**Proposed Temporary Open Storage of Construction Materials for a Period of 3 Years and Filling of Land at Lots 360 A S.A (Part), 360 A RP (Part), 360 B S.A (Part), 360 B RP (Part), 360 C S.A (Part), 360 D S.A (Part) & 360 D RP (Part) in D.D.87, Ta Kwu Ling, N.T.**

This letter intends to supersede our letter dated 18.7.2024. Our response to the comments of the Transport Department is shown in the attachment.

## Response to the comments of Transport Department

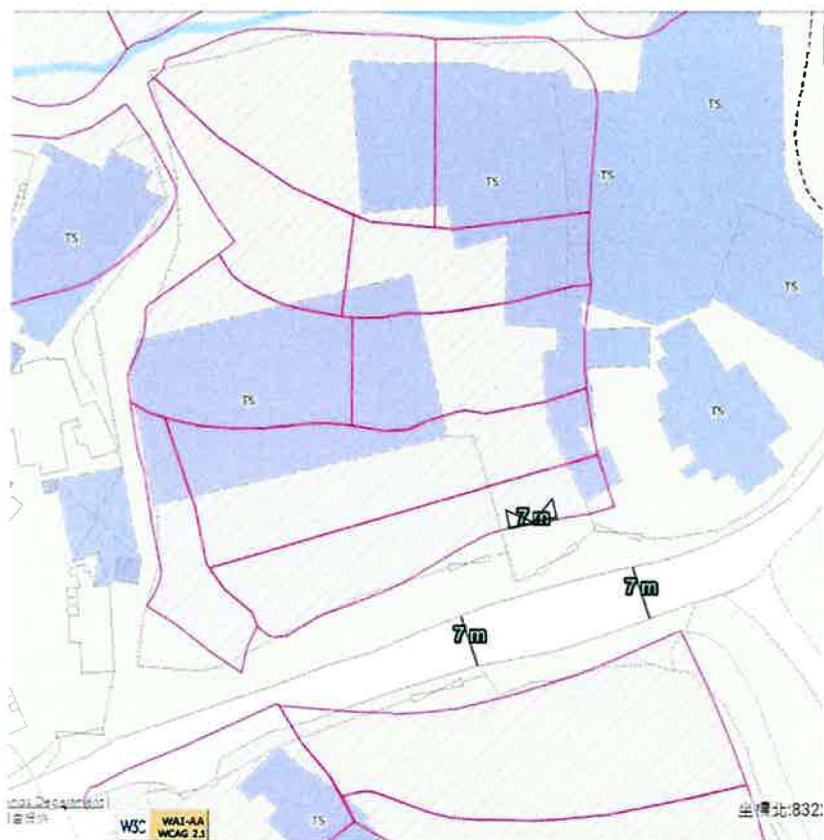
CE/MN, DSD's comments	Applicant's response
It is noted that the application site is within an existing fenced-off site (with the boundary highlighted blue below). Would the applicant please advise the usage of the remaining area, and how the proposed development would affect the existing drainage system of the existing fenced-off site	The remaining area outside the application site within the fencing will be left vacant and no filling of land would be carried out. The proposed development would not affect the existing drainage system of the existing fenced-off site because surface U-channel is proposed with calculation.

The proposed works would be at least 3m away from the watercourse and would not create any adverse drainage impacts, both during and after construction. Proposed flooding mitigation measures if necessary would be provided at the resources of the applicant to DSD's satisfaction.

Updated drainage plan is provided. 100mm gap will be provided at the toe of the site hoarding to allow unobstructed flow of surface runoff.
